OUTLINE OF NEW FEATURES

The following changes have been made for the new HIACE.

04Z6MO01

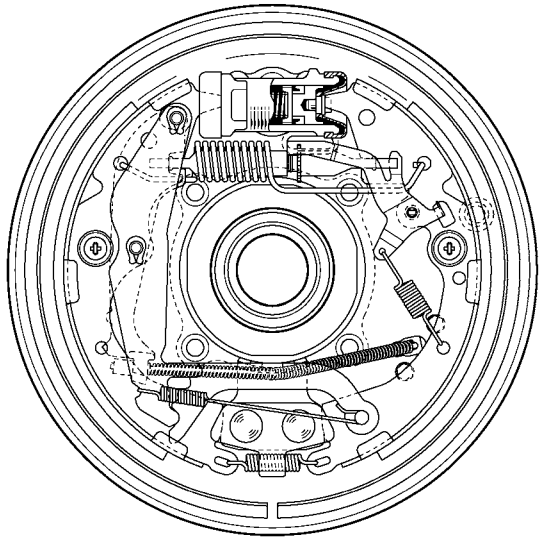
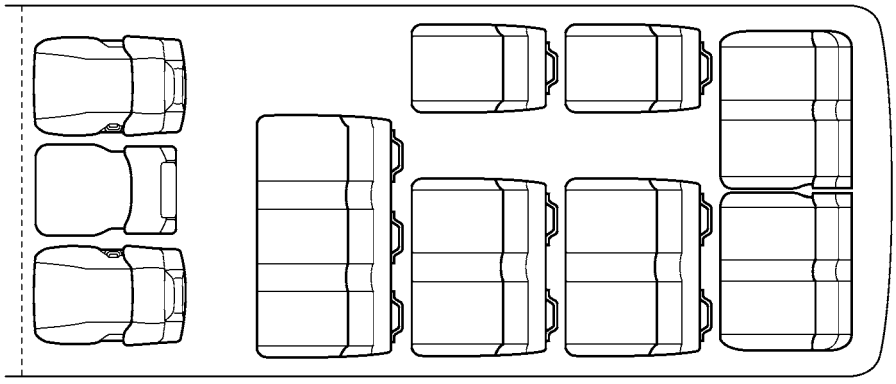
Rear brake specification for some models has been changed, as indicated in the table shown below.

Model			New Model	Previous Model
Vehicle Type			Commuter	←
Body Type			4-door, High Roof, Wide	←
Wheel Base Type			Super Long	←
Gear Shift Type			5-Speed Manual	←
Destination			South Africa and Thailand and General*	←
Rear Brake Type			Leading-trailing Drum	←
Parking Brake Type			Leading-trailing Drum	Dual Mode Drum
Rear Brake	Lining Area	cm^2 ($in.^2$)	147 (22.78) × 2	121 (18.75) × 2
	Wheel Cylinder Diameter	mm (in.)	25.4 (1.0)	22.22 (0.87)
	Drum Inner Diameter	mm (in.)	295 (11.61)	254 (10.0)
Parking Brake	Type		Drum	←
	Drum Inner Diameter	mm (in.)	295 (11.61)	254 (10.0)

04Z6BO02

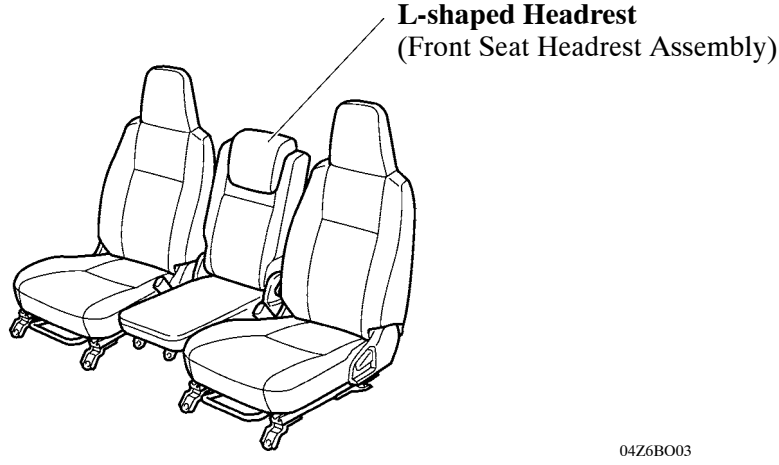
- The new DX grade of super long wheel base models for Vietnam package uses 16 (3+3+3+3+4) seat layout.
- Rear seats with head rests are available as an option for the models for Vietnam package.

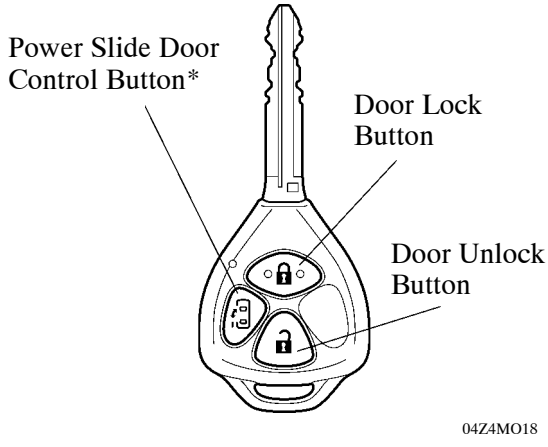
The design of the transmitter has been changed as follows.
